**VARIANCE APPLICATION**

Project/Property Address or Location: 81 S. High		Project Name/Business Name: Girard Fence	
Parcel ID No.(s): Lot 93	Zoning Designation: OG-1 <i>MS 8/3/2020</i>	Total Acreage: .17	
Description of Variance Requested: Place Cedar Fence at the end of property line along alley			
STAFF USE ONLY – Code Section(s): <i>1171.03(F) - fence height and location</i> <i>1171.03(G)(h) - Privacy fence prohibited in side + front</i>			
APPLICANT Name-do <u>not</u> use a business name: Jeff and Tracey Girard		Applicant Address: 7732 Havens Ct W Blacklick Ohio 43004	
Applicant E-mail: trgirard@gmail.com		Applicant Phone No.: 614-216-7869	
BUSINESS Name (if applicable):			
<b>ADDITIONAL CONTACTS Please List Primary Contact for Correspondence (please list all applicable contacts)</b>			
Name(s): Jeff Girard		Contact Information (phone no./email): 614-578-6446 jgirard915@gmail.com	
PROPERTY OWNER Name: (if different from Applicant)		Property Owner Contact Information (phone no./email):

RE: Project 81 S High St

## PLANNING STAFF REPORT

**SURVEY OF  
LOT 93 (12)**  
LYING IN  
GAHANNA

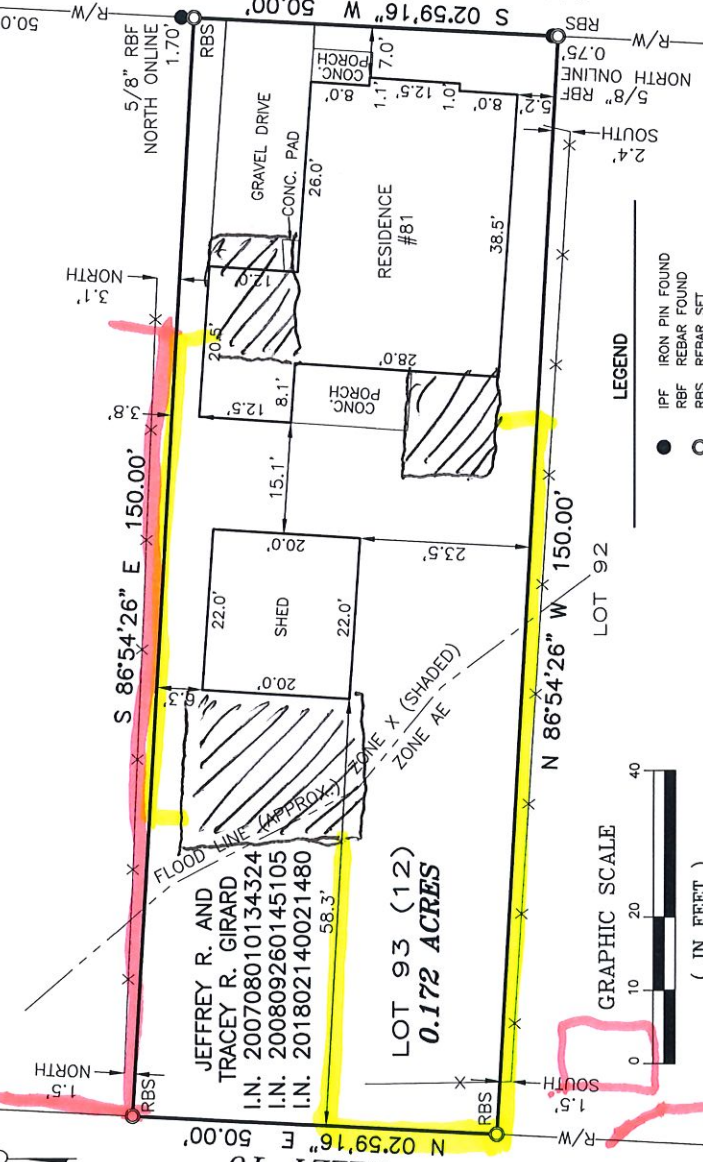
*Yellow = proposal location*  
*Pink = existing fences*  
*MB 8/17/20*

We are requesting the elimination or reduction of the 25 foot setback for a fence on the back of the property.

### Survey/Site Plan

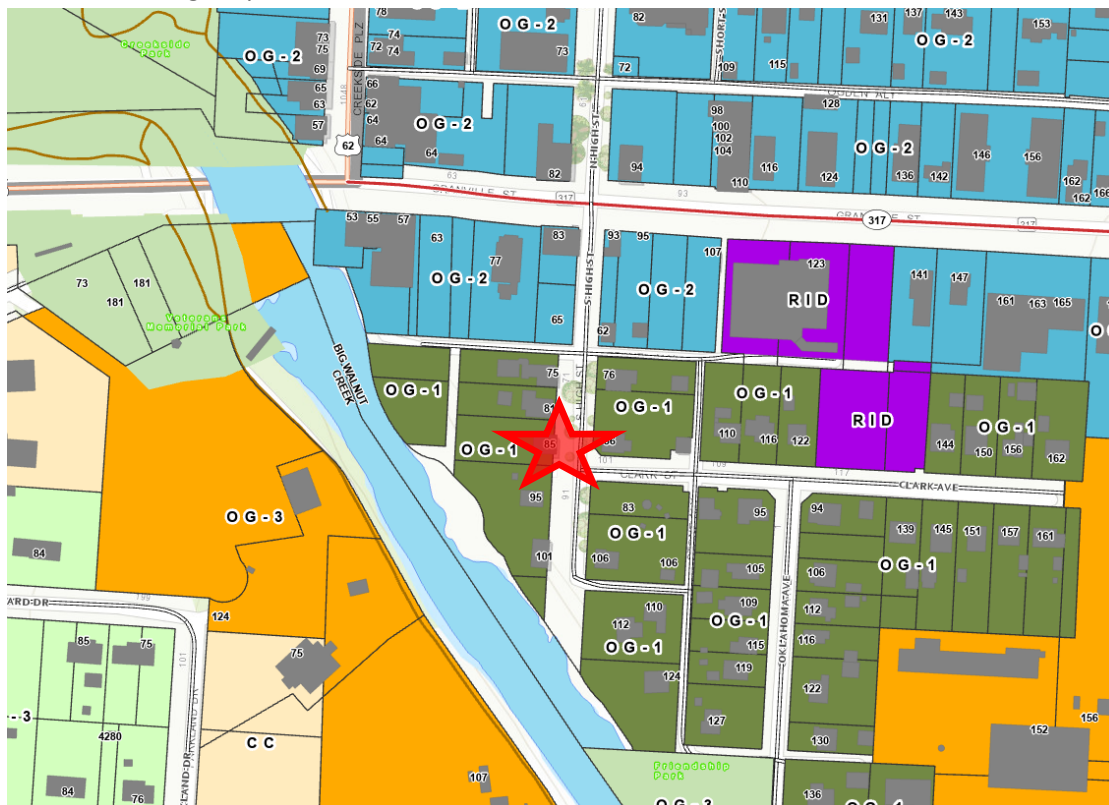
The property is zoned Olde Gahanna (OG-1) but fencing isn't dictated by the zoning designation. Front, side, and rear yard dictate fencing type and height. The site plan below shows the requested location of the fence in yellow. These areas would normally be considered a rear yard if not for the 16' wide alley on the west (left) side of the property. The alley does not serve as a street for a host of properties. The alley terminates near the subject property. The alley functions more as a part of a public parking lot. See pictures below.

Yellow = Proposed

Pink = Existing

Staff recommends approval of the variance as submitted. Surrounding properties have similar fencing in the “front yard”. This particular alley doesn’t serve as a street. It functions more as a drive aisle in a public parking lot.
